Attachment B

Revised Technical Specification Pages

Attachment C

Marked-up Technical Specification Pages

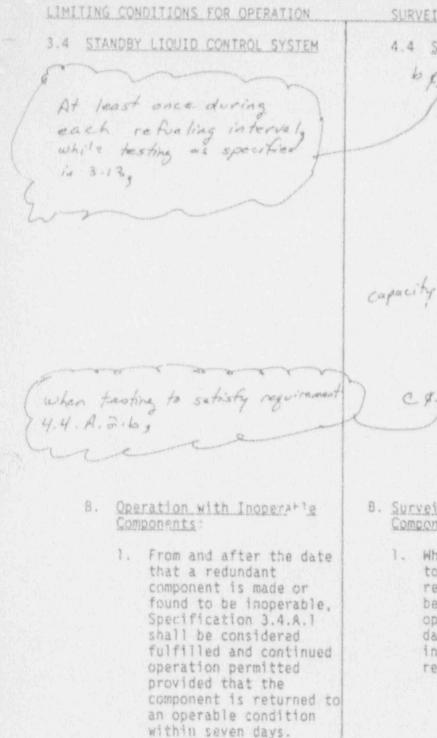
when tested as perified in 3.13 verify that each pump delivers of least 39 GPM against a system head of 1275 psg

- when tested as specified in 3.13 verify that each pump delivers at least 39 GPM against a system head of 1275 psig.
- 2. As required below:
  - a. Once each refueling interval while testing as specified in 3.13 verify the system relief valve set point of 1425 psig ± 43 psig.

#### 3.6.D <u>Safety and Relief Valves</u>

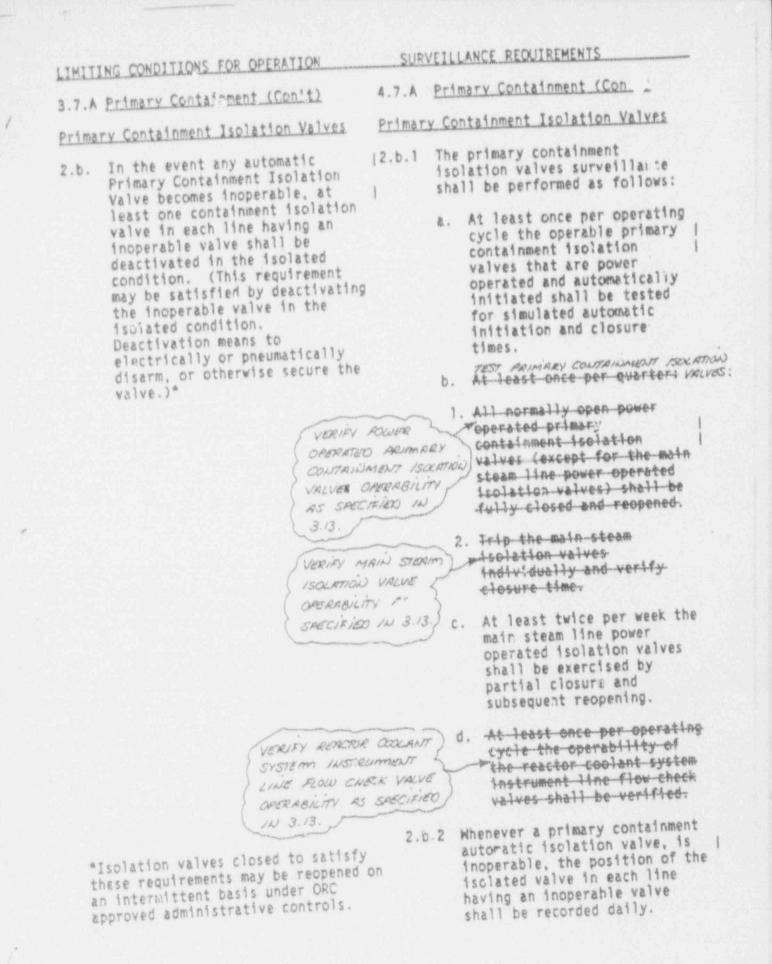
- 1. During reactor power operating conditions and prior to reactor startup from a Cold Condition. or whenever reactor coolant pressure is greater than 104 psig and temperature greater than 340°F, both safety valves and the safety modes of all relief valves shall be operable. The nominal setpoint for the relief/safety valves shall be selected between 1095 and 1115 psig. All relief/safety valves shall be set at this nominal setpoint ± 11 psi. The safety valves shall be set at 1240 psig + 13 psi.

- If Specification 3.6.D.1 is not met, an orderly shutdown shall be initiated and the reactor coolant pressure shall be below 104 psig within 24 hours. Note: Technical Specifications 3.6.D.2 - 3.6.D.5 apply only when two Stage Target Rock SRVs are installed.

- Testing of safety and relief/safety valves shall be in accordance with 3.13.
- At least one of the relief/safety valves shall be disassembled and inspected each refueling outage.
- Whenever the safety relief valves are required to be operable, the discharge pipe temperature of each safety relief valve shall be logged daily.
- Instrumentation shall be calibrated and checked as indicated in Table 4.2.F.
